RHODE ISLAND CONTRACT NO.2017-CB-070

**Horton Farm Bridge No. 472**

**NOTICE TO PROSPECTIVE BIDDERS**

ADDENDUM NO. 5    Prospective bidders and all concerned are hereby notified of the following changes in the Plans, Specifications, Proposal and Distribution of Quantities for this contract. These changes shall be incorporated in the Plans, Specifications, Proposal and Distribution of Quantities, and shall become an integral part of the Contract Documents.

SCALE: 1 1/2"=1'-0"

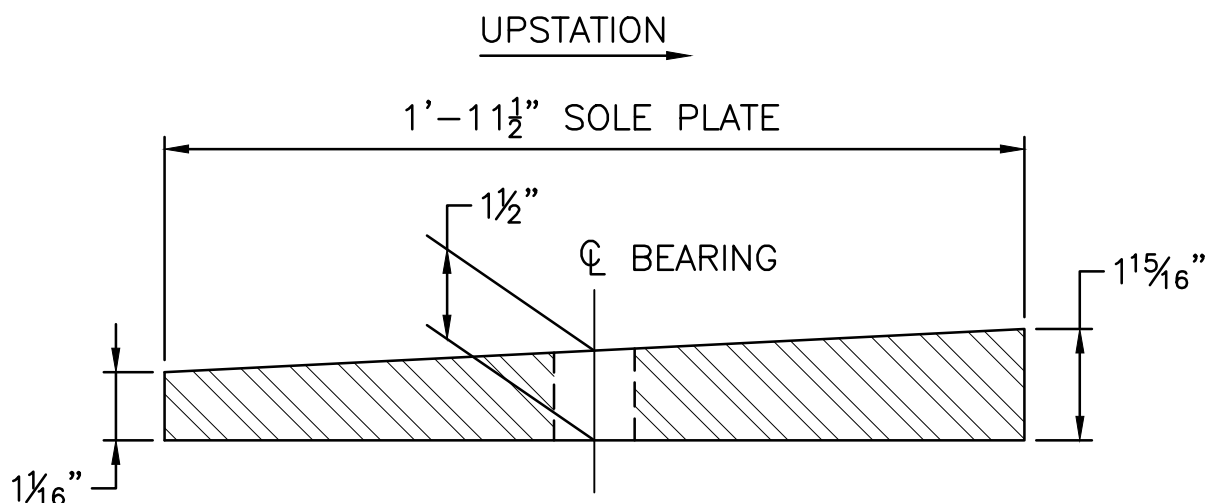
10. VOLUME 2 SHEET 45 - BEARING DETAILS SHEET 2 OF 3  
Remove and replace Sheet 45 in its entirety with Sheet 45(R-1) attached to this Addendum No. 5.  
This sheet has been revised.

REVISIONS			RHODE ISLAND DEPARTMENT OF TRANSPORTATION  IMPROVEMENTS TO I-195 ABC BRIDGE NO. 472 OVER I-195 SUPERSTRUCTURE REPLACEMENT EAST PROVIDENCE, RHODE ISLAND  ROADWAY JOINTS
NO.	DATE	BY	
1	12/13/17	LBG	
CHECKED BY <u>PNF</u> DATE <u>9/22/17</u> SCALE <u>AS NOTED</u>

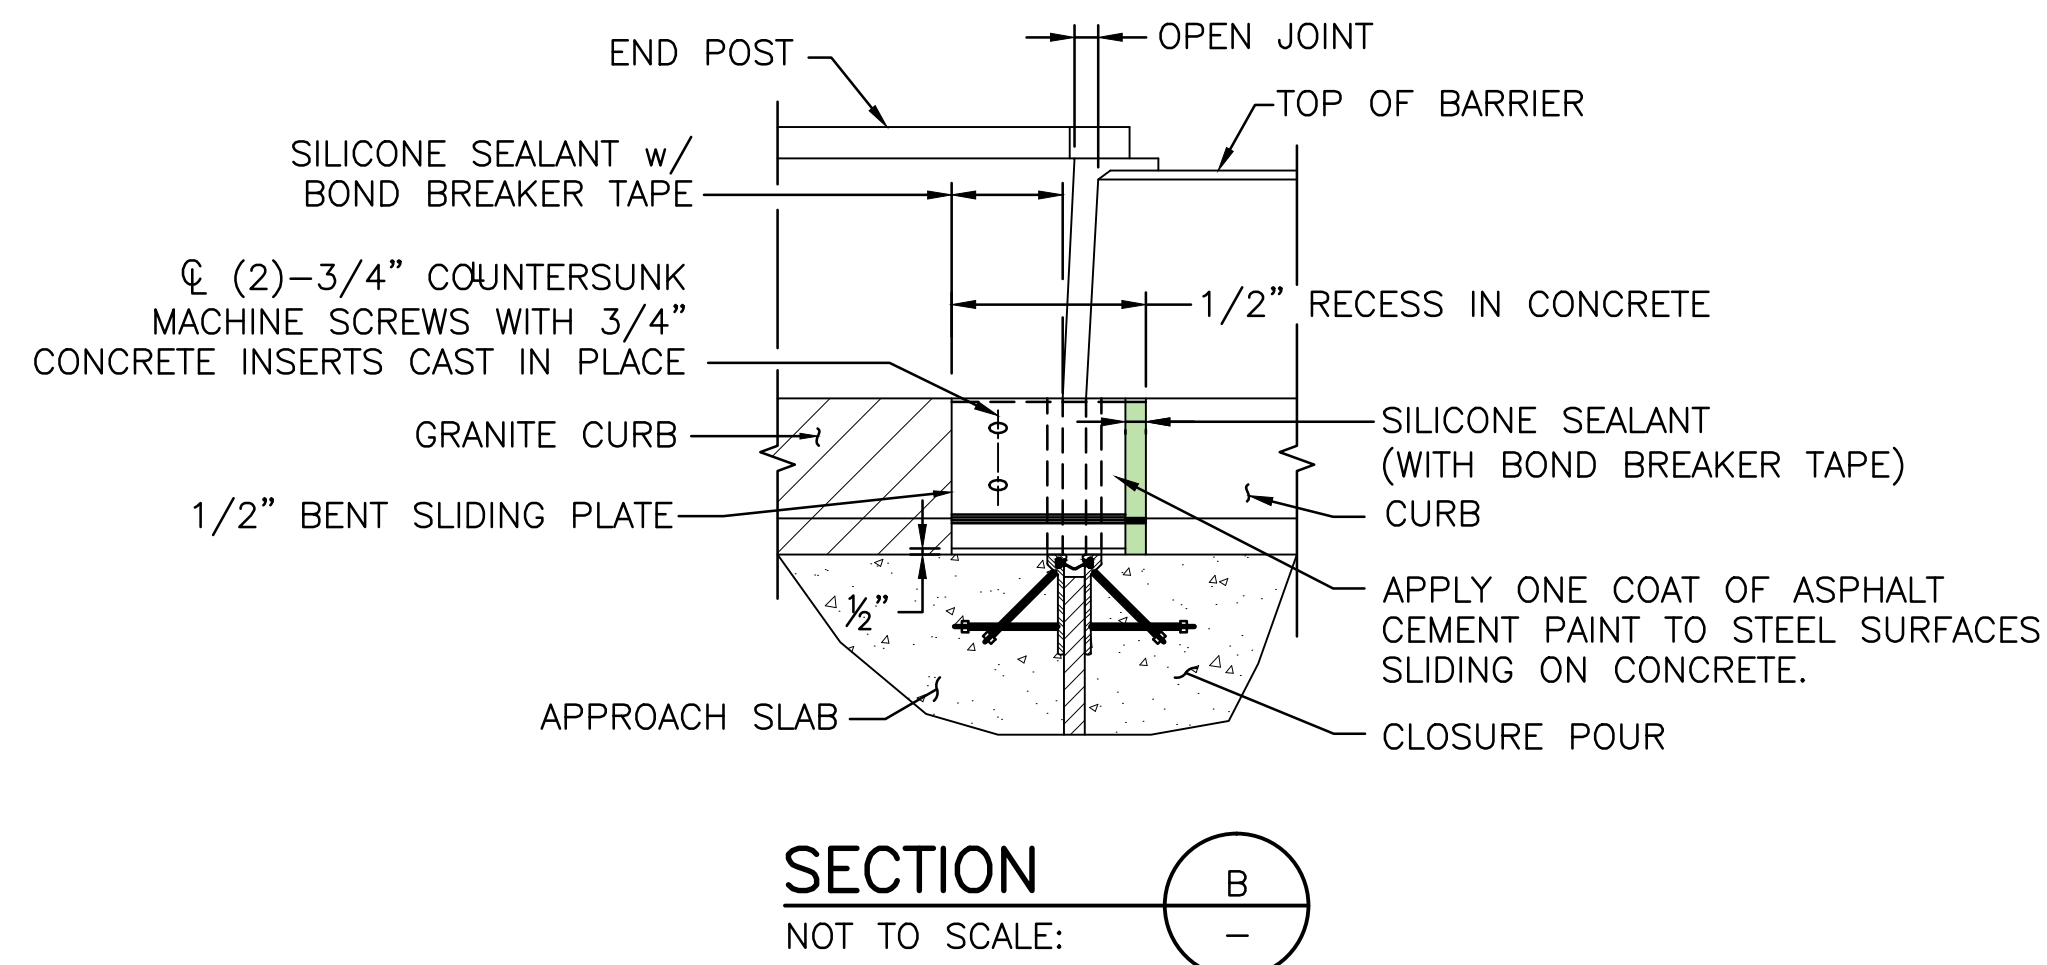
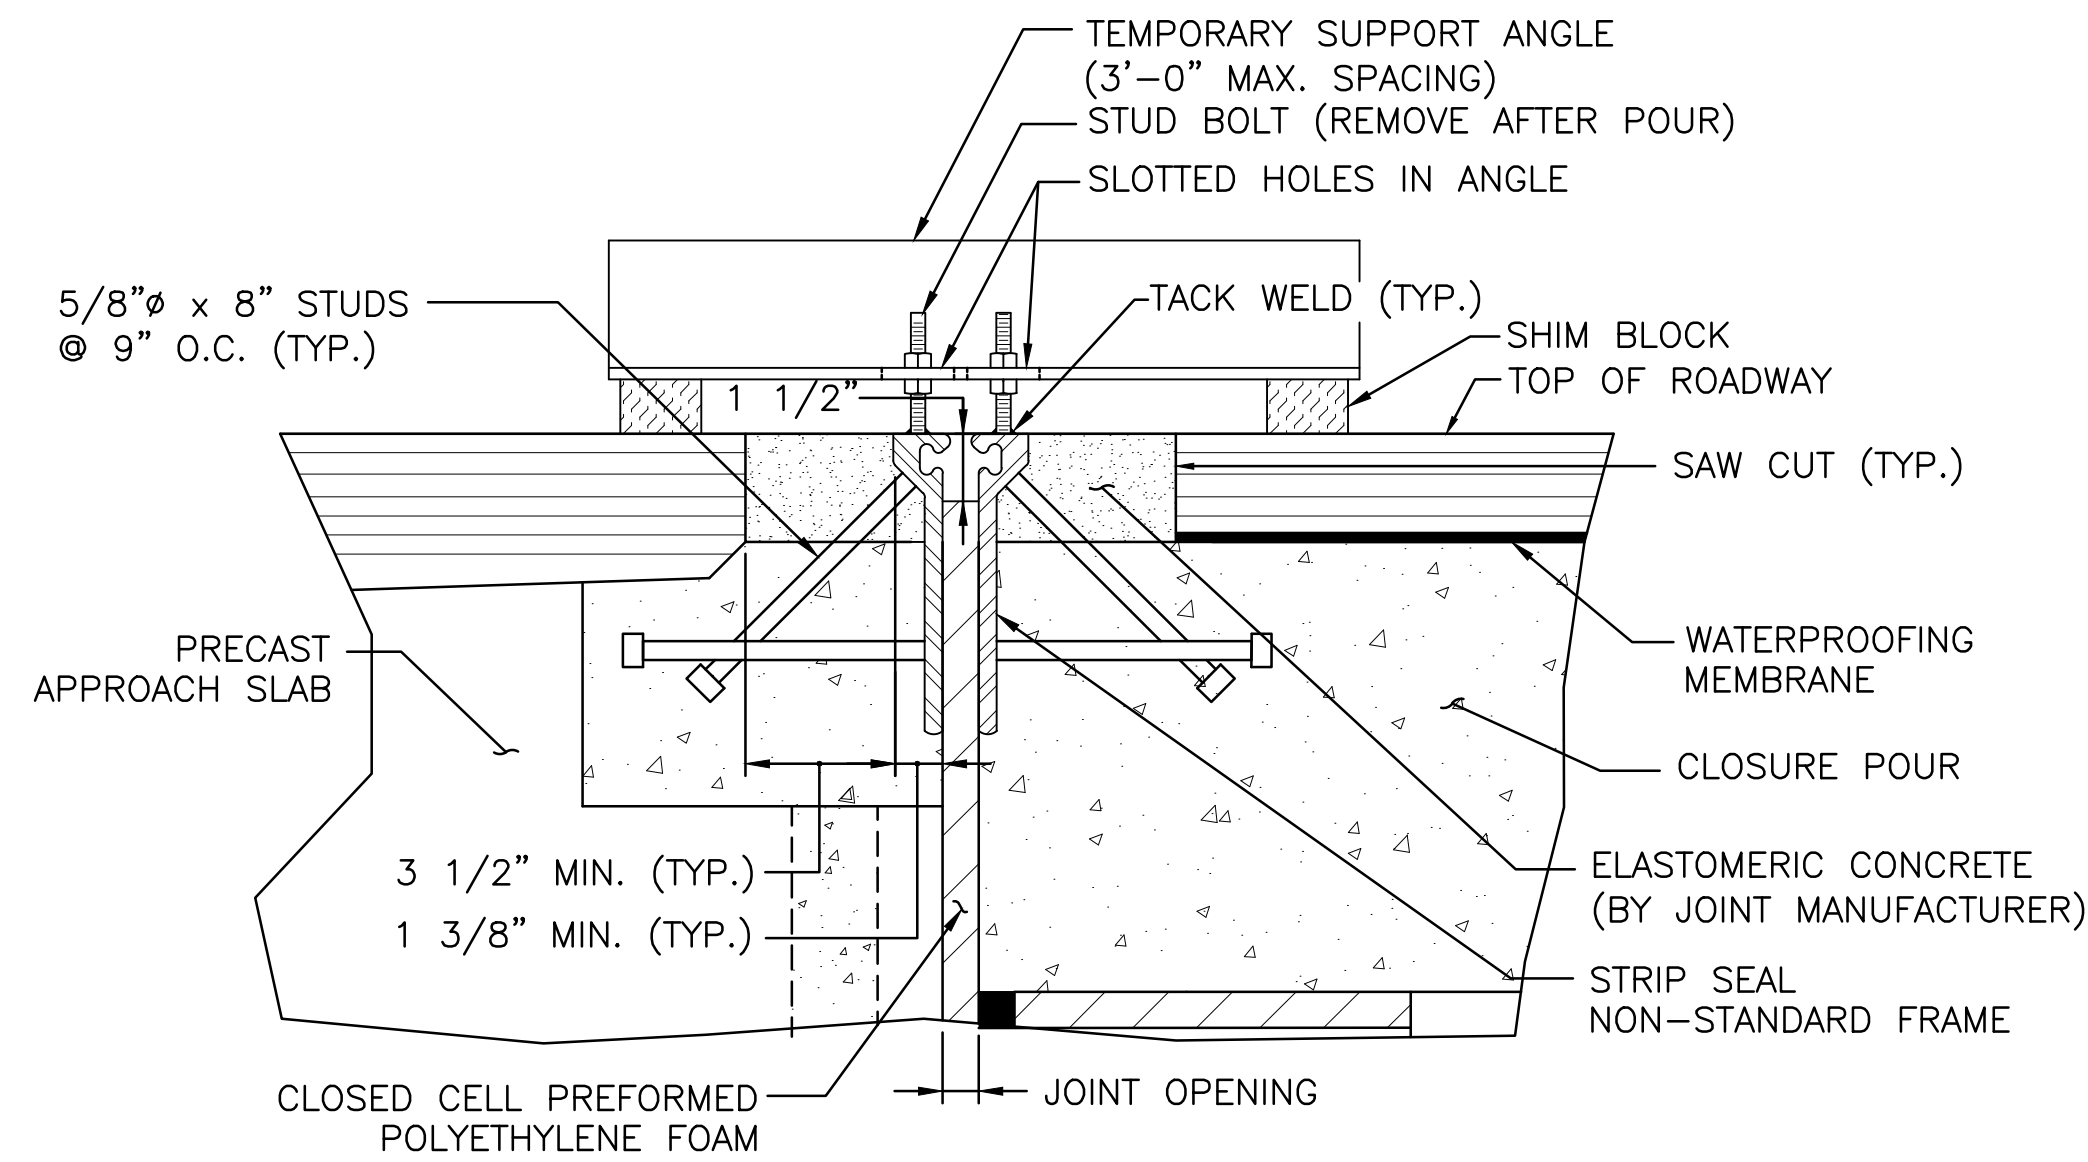
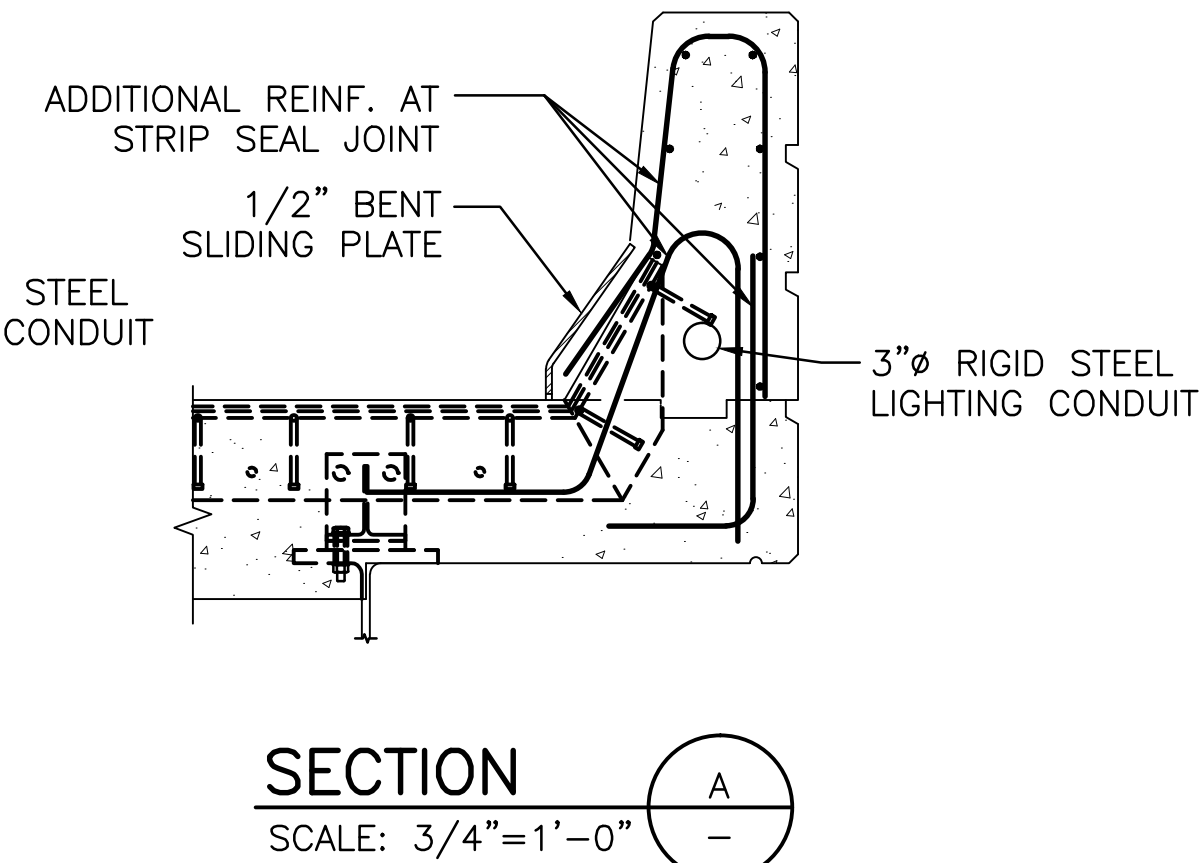
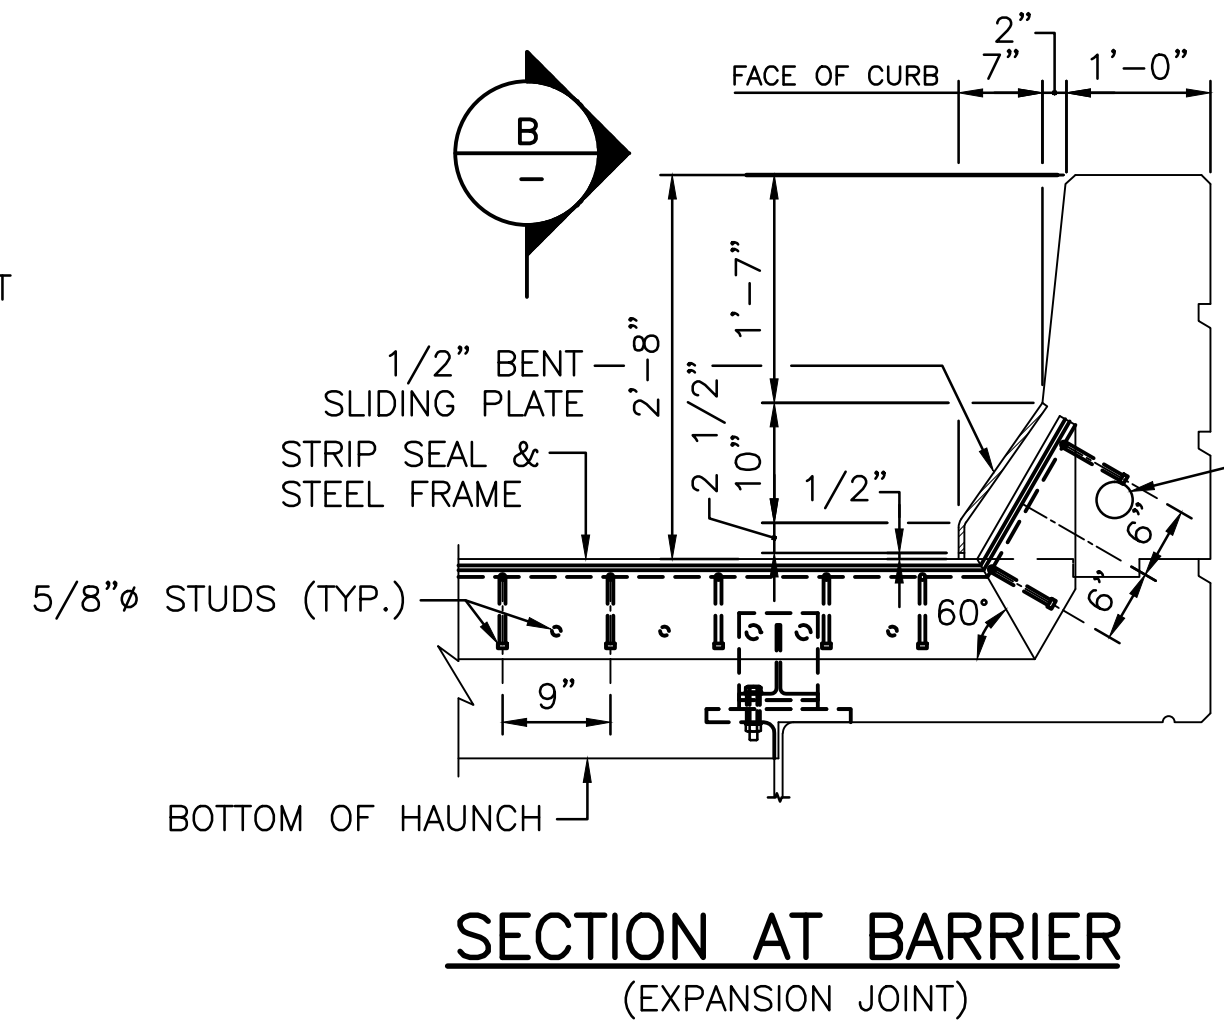
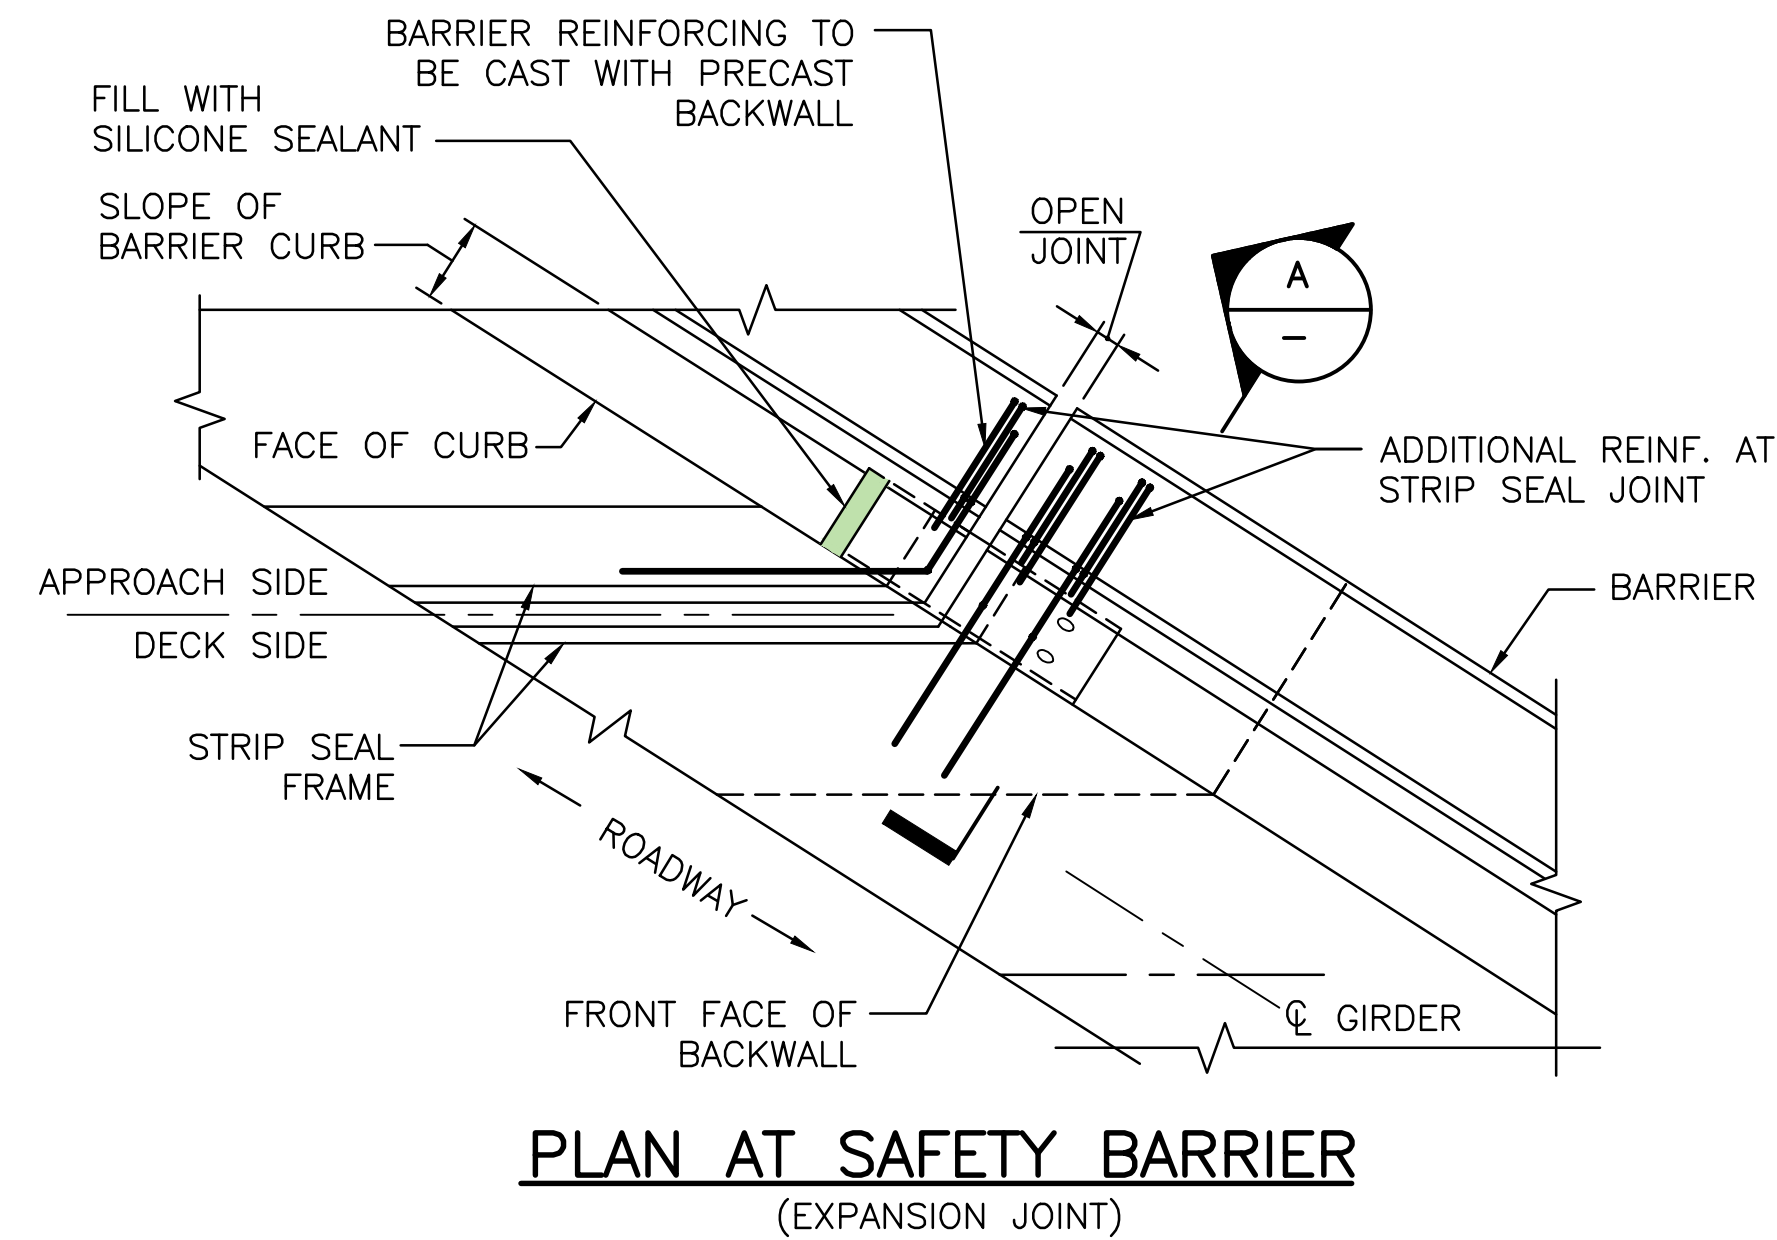
12. VOLUME 2 SHEET 47 - ROADWAY JOINTS  
Remove and replace Sheet 47 in its entirety with Sheet 47(R-1) attached to this Addendum No. 5.  
This sheet has been revised.
